**Wichita-Sedgwick County Metropolitan Area Planning Department**

October 14, 2010

**RE:** **BZA2010-48: Sign Code Adjustment to permit an electronic message sign for an institutional use on property zoned SF-5 Single-family Residential.**

**Legal Description: Lot 14, Block 5, Balthrop Addition to Wichita, Sedgwick County, Kansas, generally located at Greenwich Road and Central Avenue (600 N. Greenwich Road).**

Dwg.#
906892-2

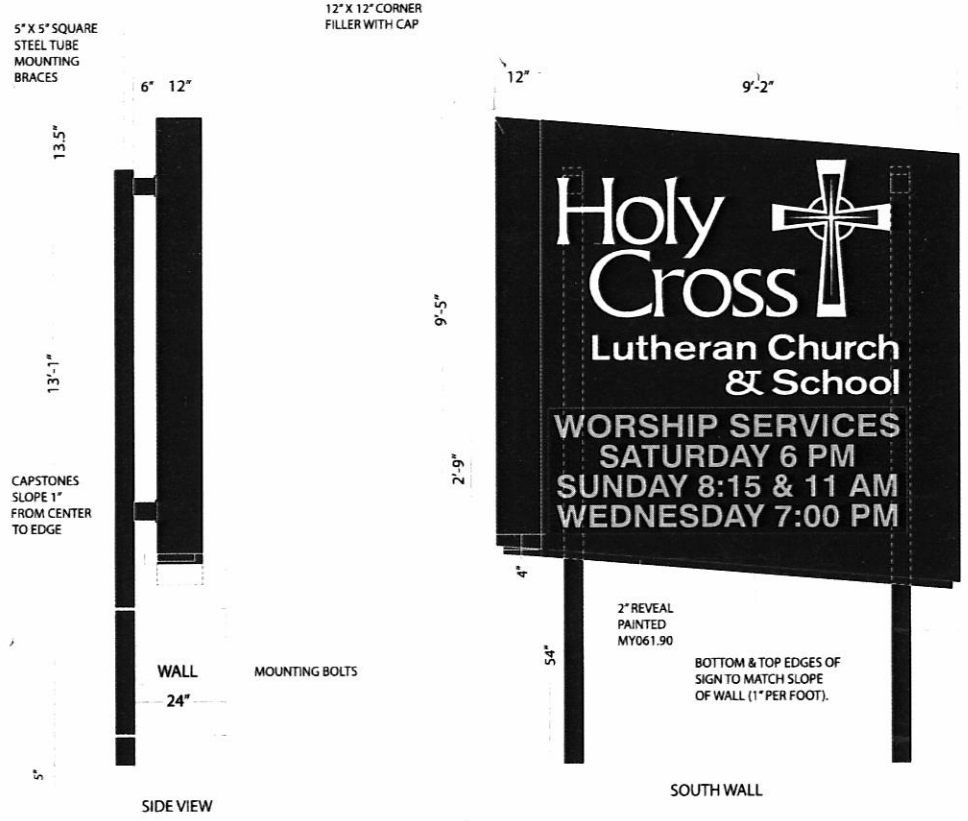
This administrative adjustment only applies to the LEC portion of the total submitted sign package and does not apply to the larger sign.

1) This adjustment shall be limited to an electronic message sign of approximately 8 feet x 3 feet in single face dimensions and as part of an otherwise conforming sign.

2) The sign shall be installed at approximately the location of the existing brick monument wall.

3) No animated, flashing or moving images or text shall be displayed on the sign; the sign shall not make copy or graphics changes faster than once per second.
